Combroke Parish Council

Consultation for Planning Application 16/ 02796/FUL

Proposal: Demolition of existing buildings, change of use, and erection of new dwelling.

at: property known as: Combrook Garage, Combrook CV35 9HP.

Appendix 1:
Site survey superimposed on
proposed site plan

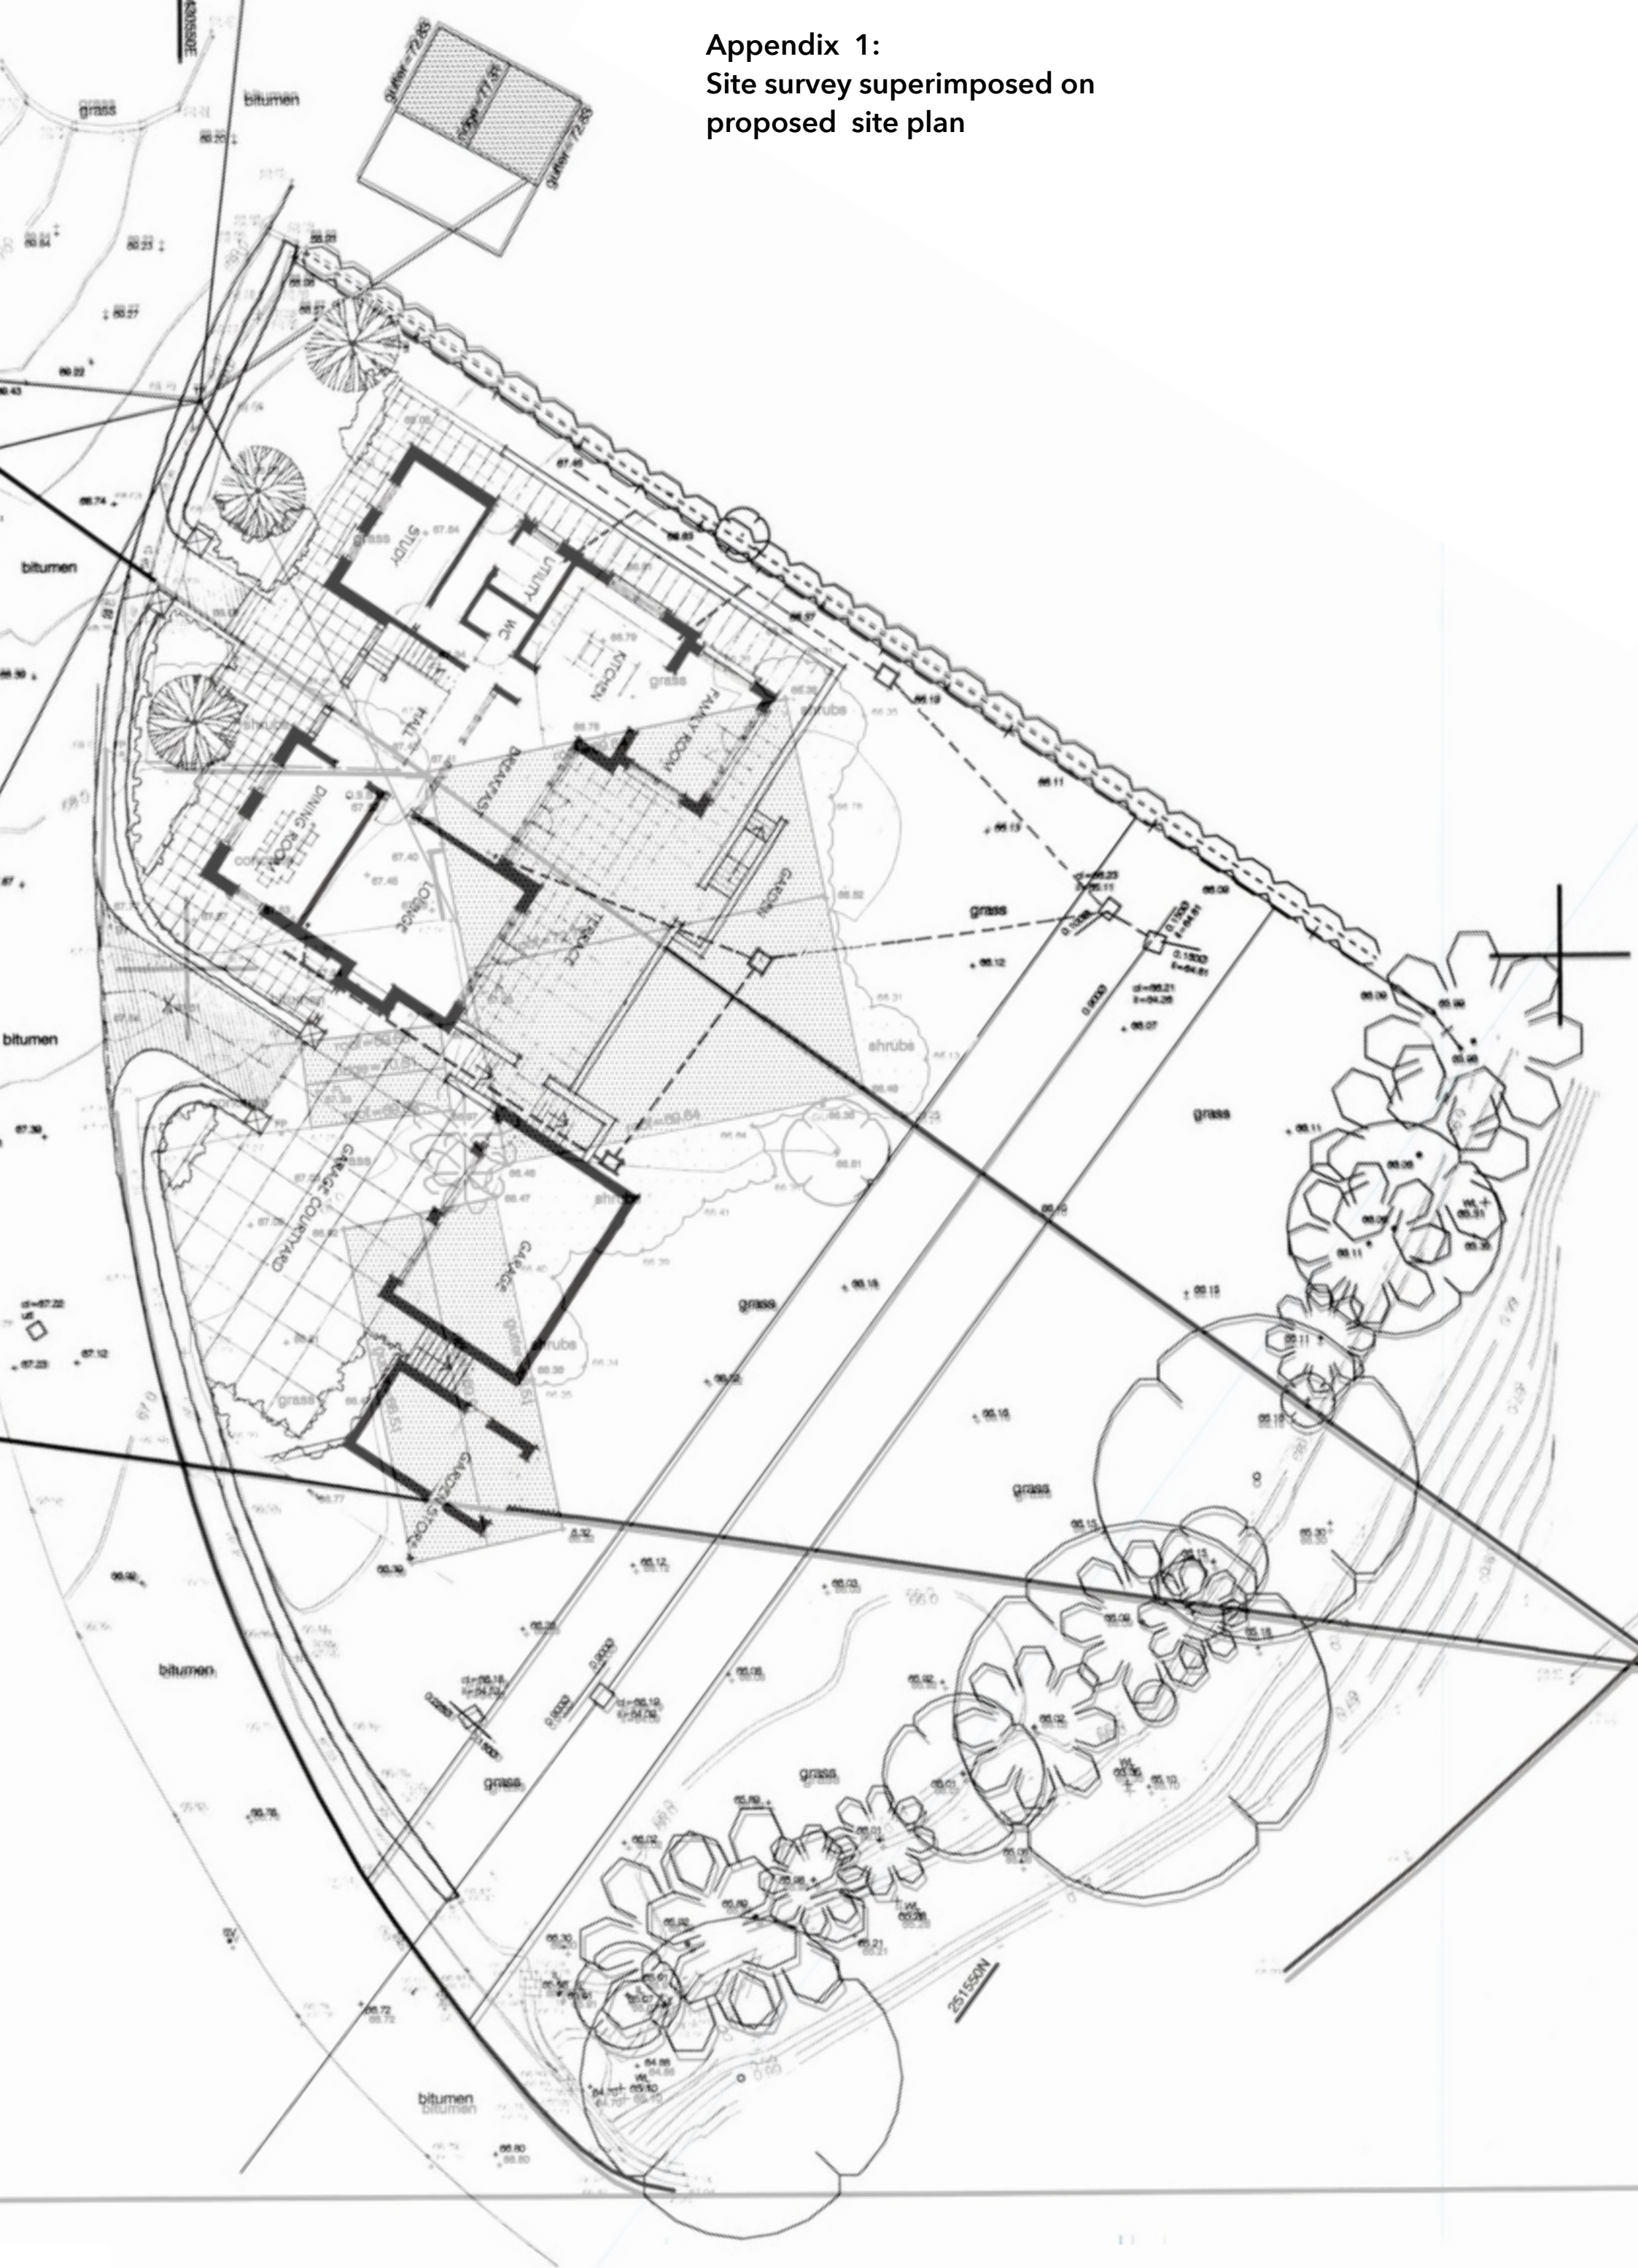
- 4.2. Appendix 1 shows the current site superimposed upon the proposed plan. The applicant acknowledges in the design and access statement that the current buildings are on the flood plain. This scheme builds over much of the existing footprint.

- 4.5. The proposal includes a substantial 1.7m high terrace across the site. This will be well within the flood plain. In a flooding event this 1.7m high terrace will create a backwash of floodwater upstream and across stream and put existing properties under increased risk. This is unacceptable.

Appendix 2

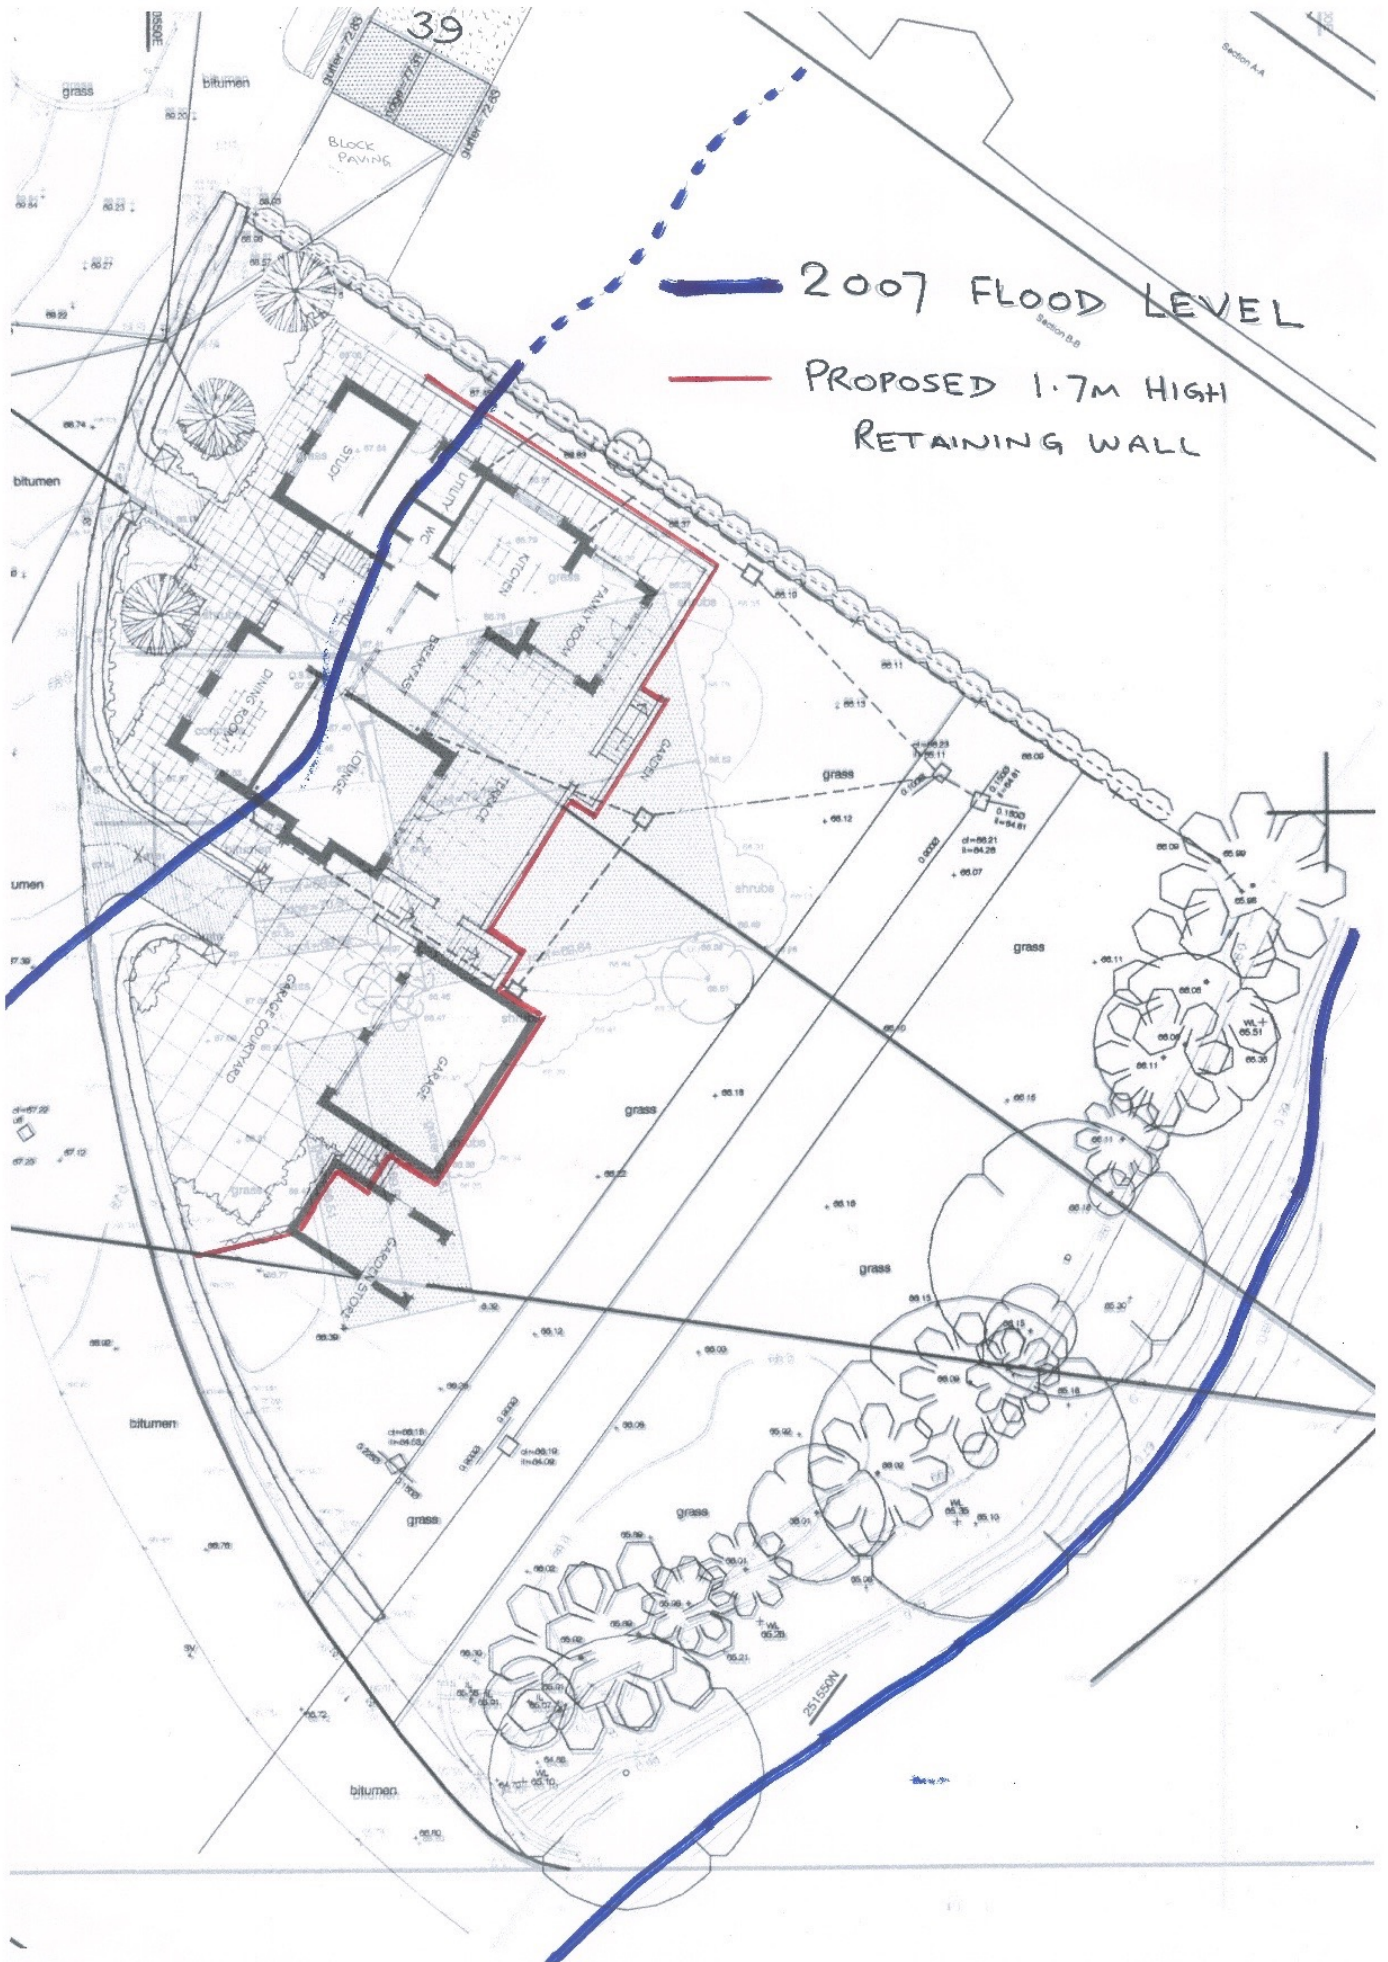
- 4.3. Appendix 2 provides photographs of the extent of flooding in 1998, 2007 and the more limited flooding in March 2016. Dr Tim Goodhead has submitted a detailed objection to the Planning Authority on the grounds of flooding and provides an outline of the extent of the 2007 flood level on the site plan. A copy of this is attached at appendix 3. This is based on local knowledge, photo evidence and site contours from which it is clear that much of the proposed dwelling will be on the flood plain ~as defined by its extent in 2007. This flooding was likely to be a combination of surface and river flooding.
